**Snowdonia Aerospace Airspace Change Proposal
Revised Design (Stage 4A), ACP-2019-58
Llanbedr Danger Area (DA)**

This report documents the Revised Airspace Design as part of the “Stage 4A Update Design” element of the Snowdonia Aerospace LLP submission for an Airspace Change Proposal, Reference: ACP-2019-58, Llanbedr Danger Area (DA), under the Civil Aviation Authority (CAA) CAP1616 Airspace Change Process.

Fig. 1 - Final Airspace Design (Option #2b) for ACP-2019-58, Llanbedr Danger Area, incorporating the revisions suggested from the consultation

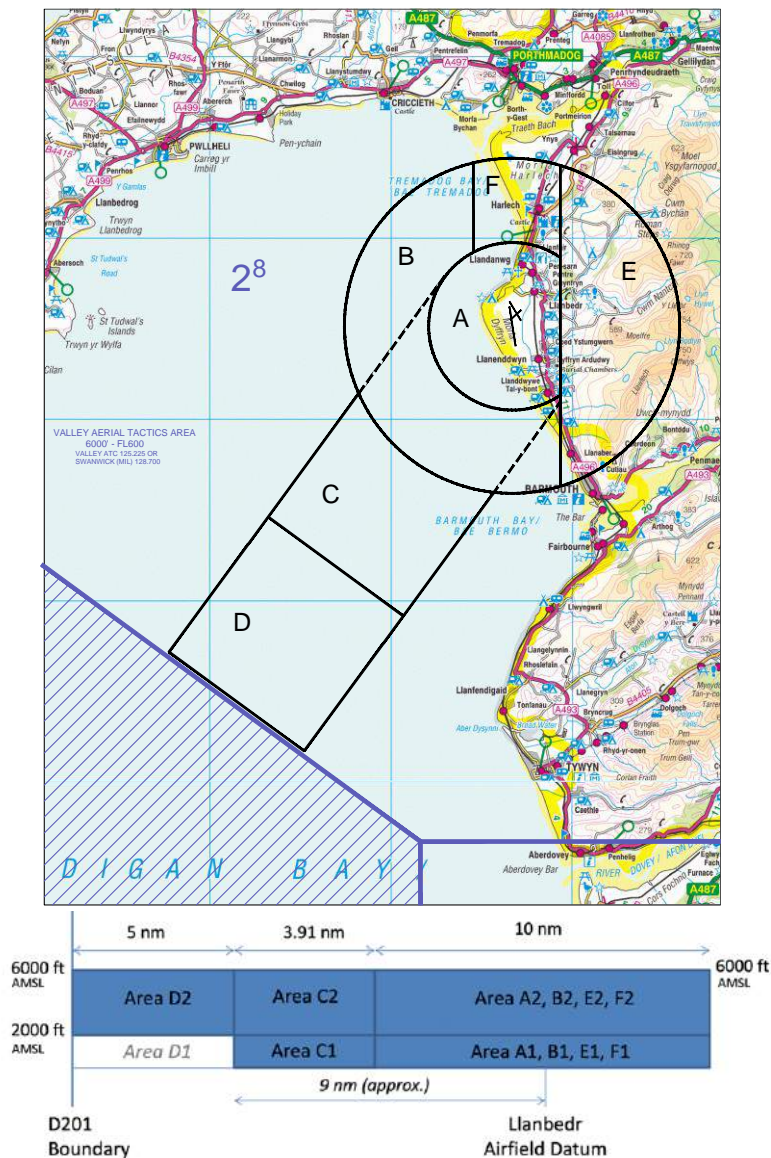
The design changes from Stage 2 to Stage 4 are:

A simplification of the sub-divisions for Areas E and F to provide easier assimilation and a clearer north-south transit corridor transit for General Aviation away from the higher ground.

A lengthening of Area D from 4 nautical miles to 5 nautical miles to provide a larger buffer between the Llanbedr DA and the existing D201 and reduce any funnelling effect for military aircraft transiting to the west between both Danger Areas.

Fig. 6 - Final Airspace Design (Option #2b) for ACP-2019-58, Llanbedr Danger Area, incorporating the revisions suggested from the consultation

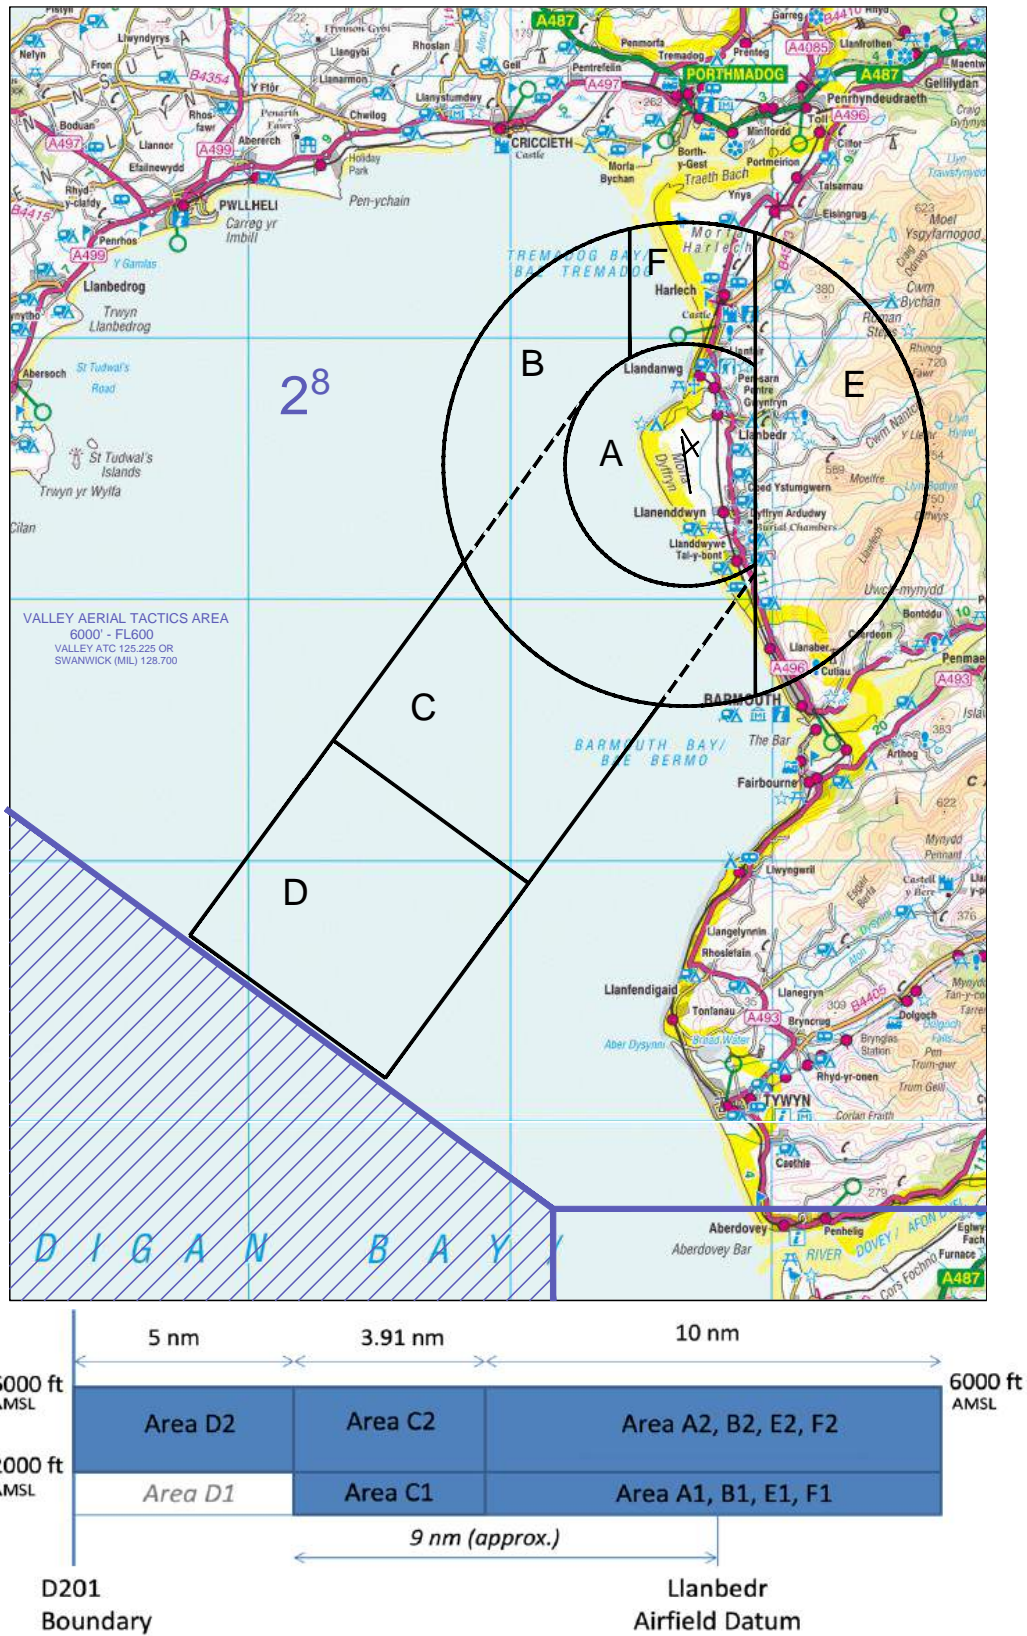
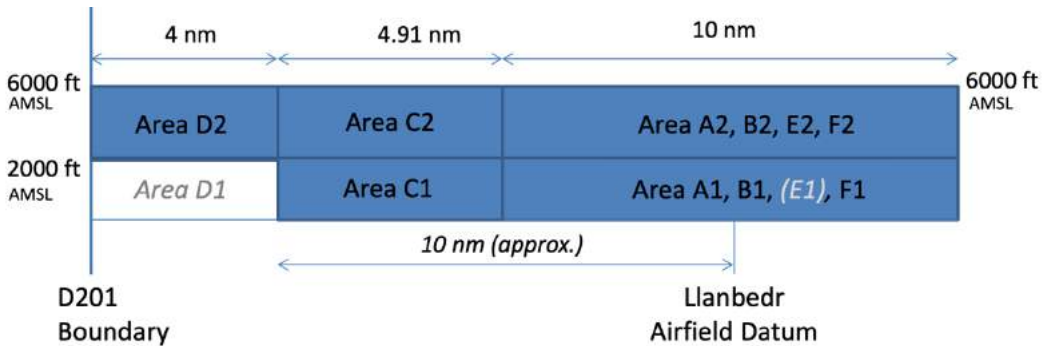
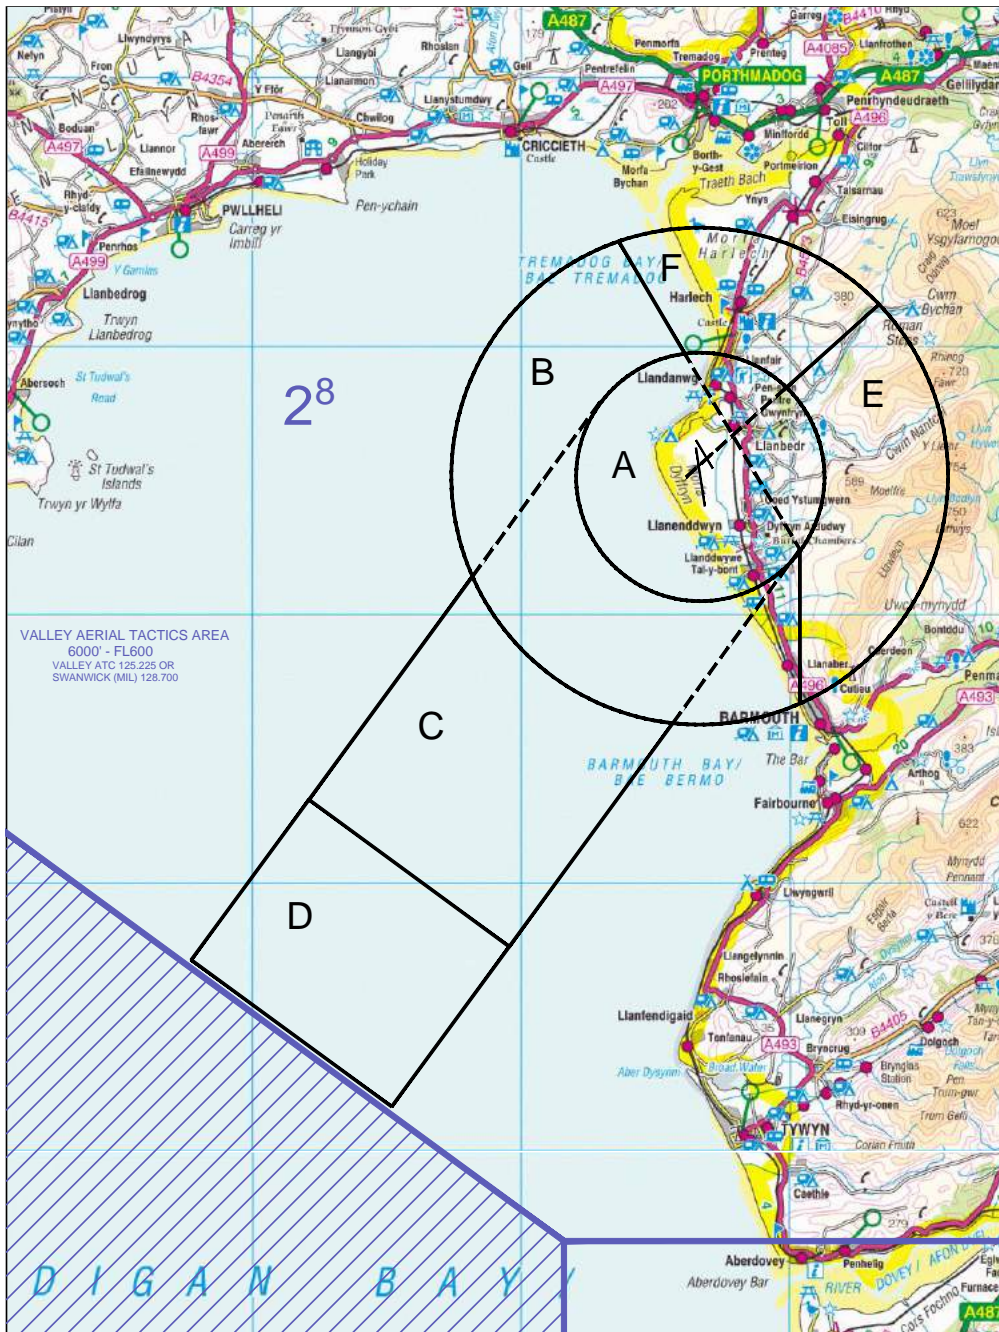
The revised design, Option #2b, is presented in Figure 6. Compared to the original Option #2 design shown in Figure 5, Area D has been increased in length from 4 to 5 nautical miles and Areas E and F have been simplified to improve GA transit to the east when Areas A, B and / or F are activated and also to ease issues raised by some respondents in relation to overland operations. This has resulted in a clipping of Area A such that it would no longer be completely coincident with an ATZ (if one were to be implemented in future) but is still entirely consistent with the major dimensions.

One particular issue raised by the MOD was in relation, in their opinion (Appendix A), to the potential for GA and other low-level military traffic to be funnelled through Area D when Llanbedr and other DAs in the vicinity were active, which may lead to a perceived increased risk of inadvertent penetrations of D201, or potentially force aircraft to fly towards the high ground inland from Llanbedr. We believe that the two main changes to the airspace design which we have now implemented as a direct result of the consultation feedback, will significantly mitigate any perceived risk by (i) creating a corridor through Area E for GA aircraft to stay to the east of the airfield for the vast majority of the time that the DA is active without having to fly towards high ground, and (ii) lengthening Area D from 4 to 5 nautical miles to increase the buffer to D201 and also reduce the potential for funnelling. Addressing (i) will also benefit item (ii) because making it easier for GA to pass to the east of the airfield will obviate the need for them to divert far out to the west and thereby leave this area clear for military aircraft to transit over / under the Llanbedr DA corridor or through the gap between the Llanbedr DA and D201.

The dimensions of Area D were previously carried over from the original definition for the TDA and had been set so as to enable an engine out (or similar emergency) recovery back into Area C (or returning to D201) without dropping through the “floor” in Area D and inadvertently entering non-segregated Class G airspace. This assumed that the recovering aircraft would have a glide ratio greater than 6:1. Increasing the length of Area D increases the required glide ratio to greater than 7.5:1, but it should be noted that a glide ratio greater than 15:1 would actually be required to recover from the far edge of Area D back to Llanbedr without ditching. Given that other mitigations should be put in place so that the risk of such an event is as low as reasonably practicable – and will be assessed as part of the CAA review of individual Operating Safety Cases (OSC) – we feel that the recovery glide ratio should not be a driving factor in the definition of Area D and that the proposed revision still represents a reasonable and proportionate balance between the competing requirements of different airspace users.
